Addendum To Revised Feasibility Study Report

**Former Kast Property
Carson, California**

Project Number: SB0484-03-03

October 15, 2014

150 75 0 150 Feet 	
Properties Exceeding Human Health and/or Leaching to Groundwater Criteria, ≤ 5 Feet Below Ground Surface Former Kast Property	
 consultants	
Santa Barbara	Revised September 2014
Figure 3-1

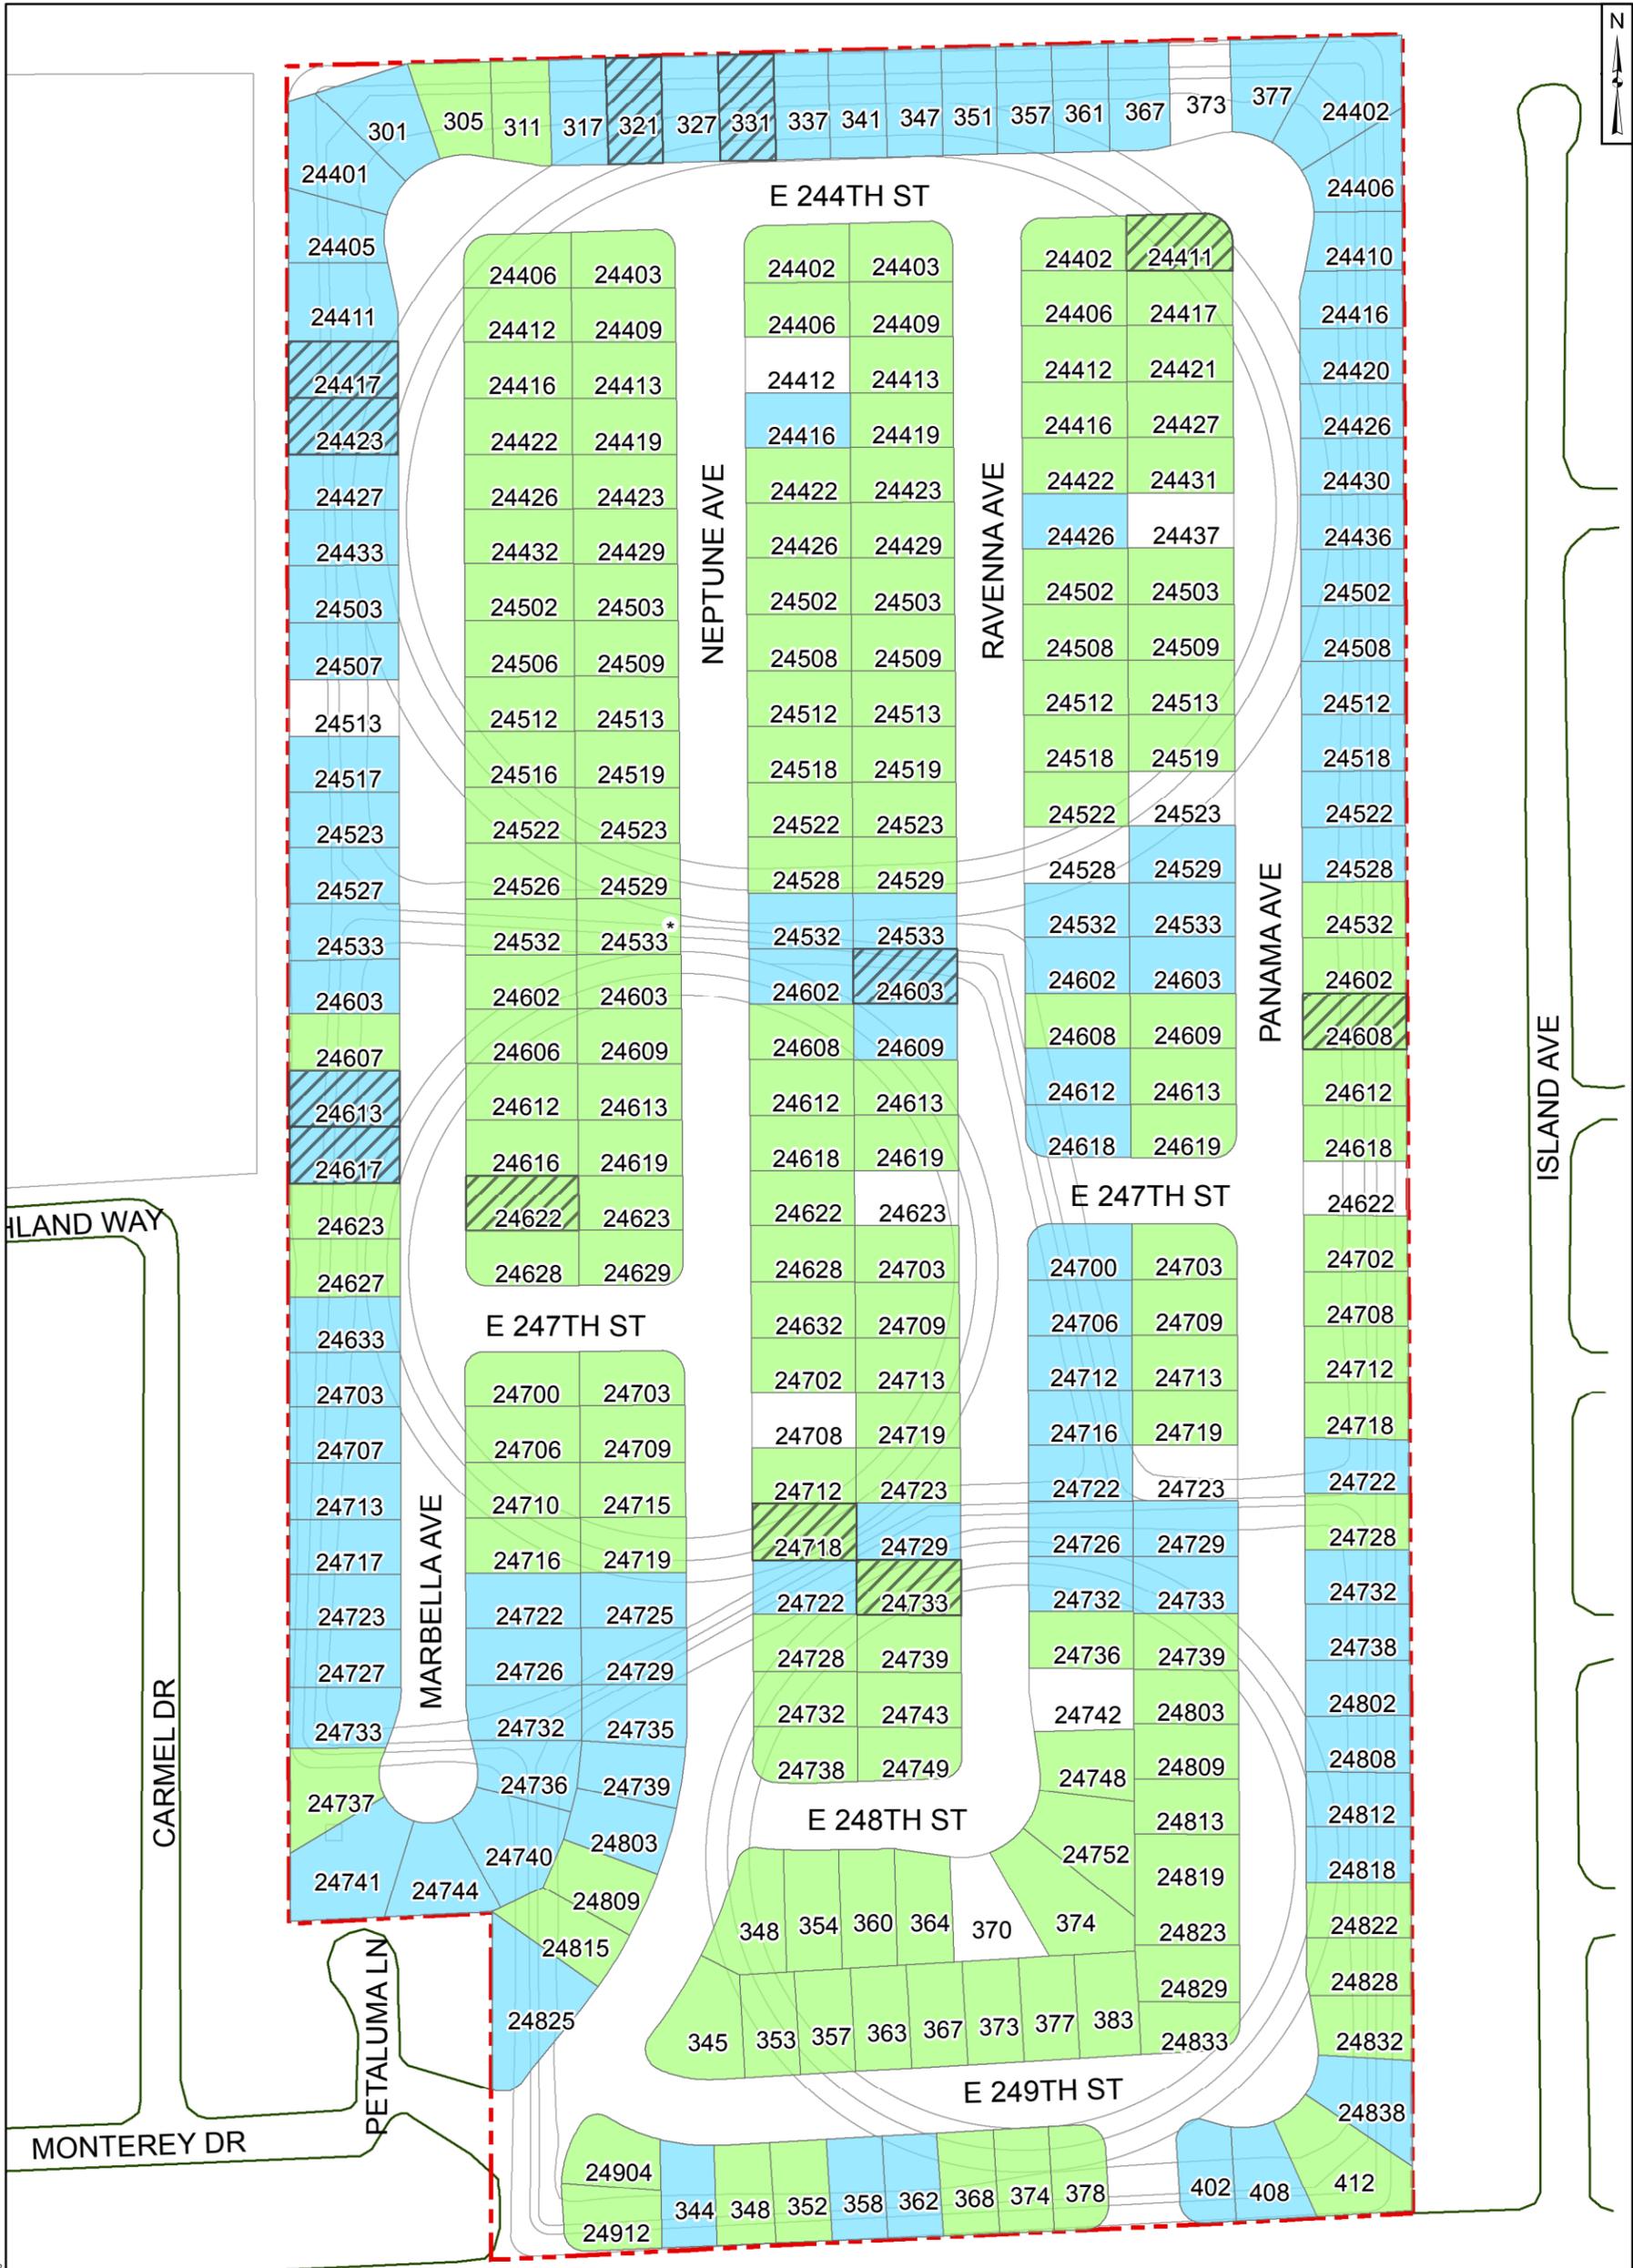
Responses to Regional Board comments on the Revised HHRA (i.e., the first two comments in the table in Section 1.2 of this Addendum) resulted in re-evaluation of arsenic and inclusion of new data collected after preparation of the Revised HHRA (Geosyntec, 2014c). For details, please see the Addendum to the Revised HHRA (Geosyntec, 2014e). As a result, the number of properties identified for excavation from 0-5 feet bgs under the preferred Remedial Alternative (4D) increased from 202 to 207. The property addresses selected for excavation from 0-5 feet bgs are identified in replacement **Table 3-3** and shown on replacement **Figure 3-1**. Also included are replacement **Figures 3-2** and **3-4** from the Revised FS updated to include data collected since preparation of the Revised HHRA. These changes to the number of properties identified for excavation are relatively minor, and they *do not* affect the analyses presented in the Revised FS (i.e., the detailed and comparative evaluations of remedial alternatives), which led to the selection of the preferred remedy (Alternative 4D). For the reasons stated in the Revised FS, Alternative 4D remains the preferred remedy.

properties will be excavated to a depth of 10 feet bgs in front and back yards, where possible, and to 5 feet bgs only in side yards. Therefore, the number of properties identified for excavation from 0-5 feet bgs has increased by another 12 properties (from 207 to 219). Properties identified for excavation from 0-5 feet bgs are summarized in replacement **Table 3-3** and shown on replacement **Figure 3-1**. The actual need for remedial action at these properties will be evaluated when access becomes available, soil sampling is conducted, and data are obtained. These changes to the number of properties identified for excavation are relatively minor, and they *do not* affect the analyses presented in the Revised FS (i.e., the detailed and comparative evaluations of remedial alternatives), which led to the selection of the preferred remedy (Alternative 4D). For the reasons stated in the Revised FS, Alternative 4D remains the preferred remedy.

Figure
3-3

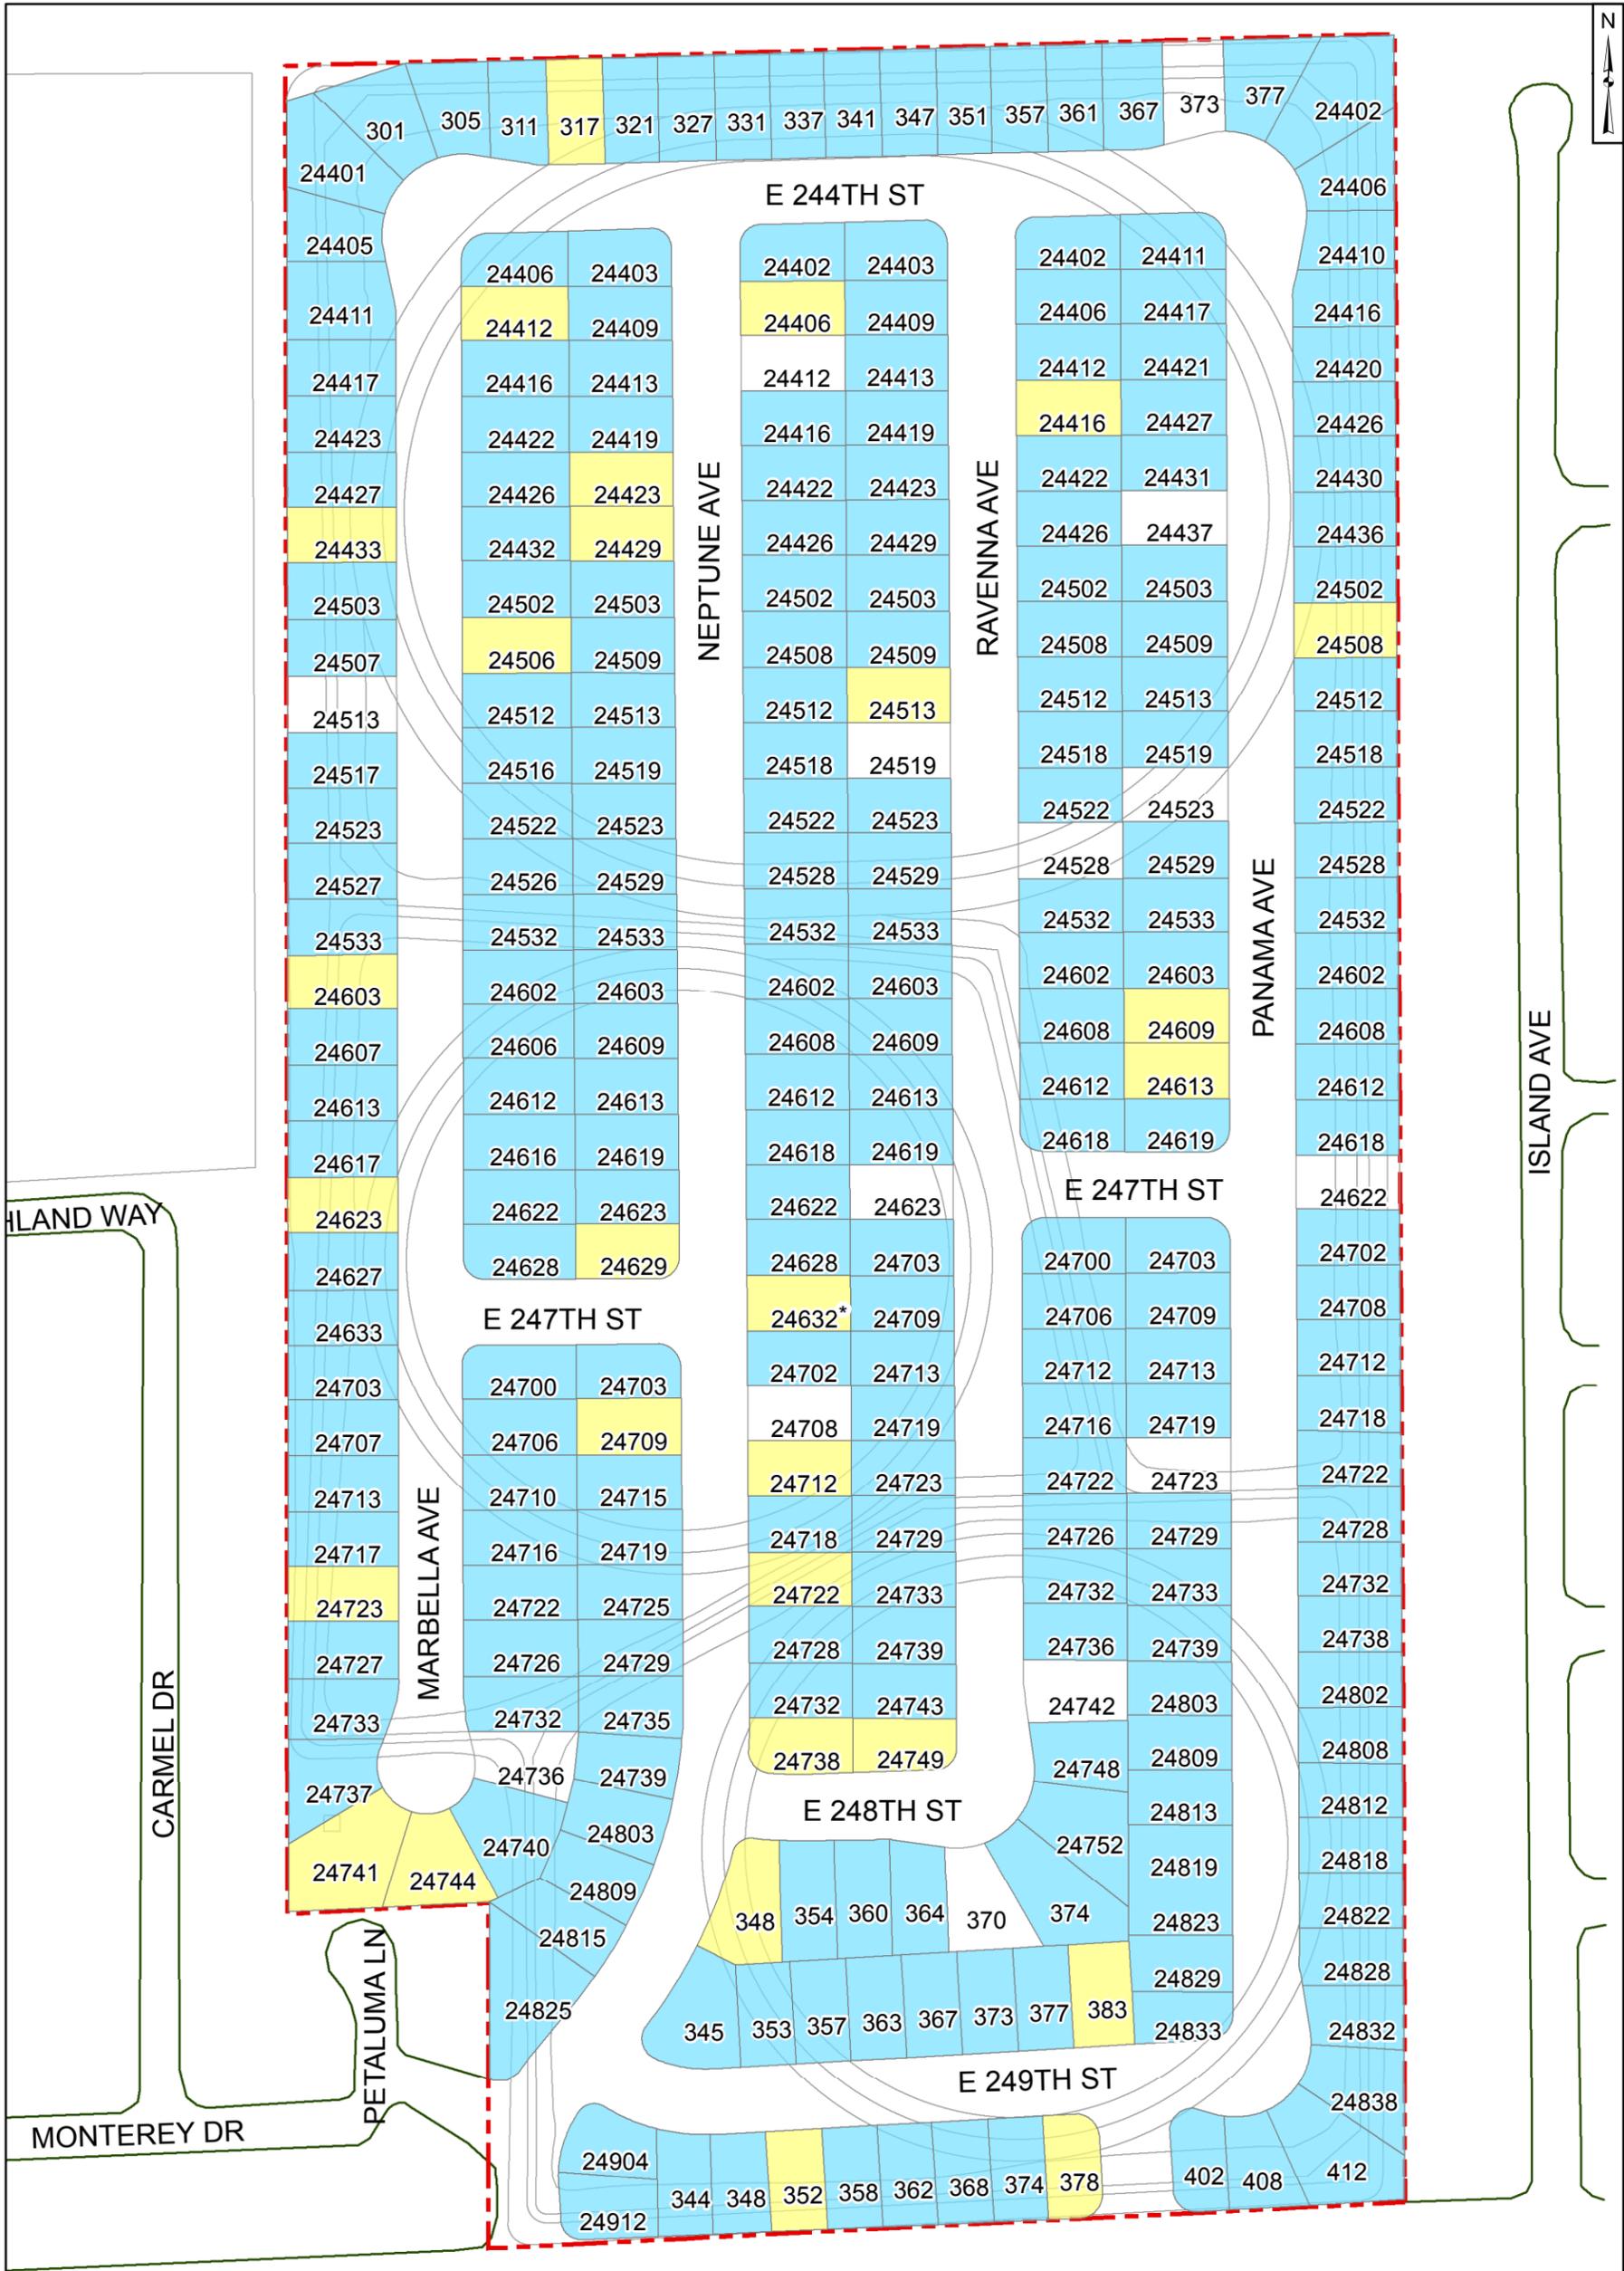
Based on the additional data evaluation for targeted mass removal from 5-10 feet bgs (Alternative 4D), an additional eight front yards were identified for deeper excavation; five of these are at properties where the back yard was previously identified for deeper excavation, and three are at additional properties not previously identified. Therefore, the number of properties and yards identified for targeted deeper excavation from 5-10 ft bgs has increased from 82 to 85 and from 115 to 123, respectively. The additional 12 properties with no soil matrix data increases the number of properties and yards identified for targeted deeper excavation by 12 and 23, respectively (from 85 to 97 and from 123 to 146). The actual need for remedial action at these properties will be evaluated when access becomes available, soil sampling is conducted, and data are obtained. Properties identified for targeted deeper excavation from 5-10 feet bgs are summarized in replacement **Table 3-3** and shown on replacement **Figure 3-3**. Some properties were identified for excavation of both front and back yards, while others were identified for excavation of only the front or back yard.
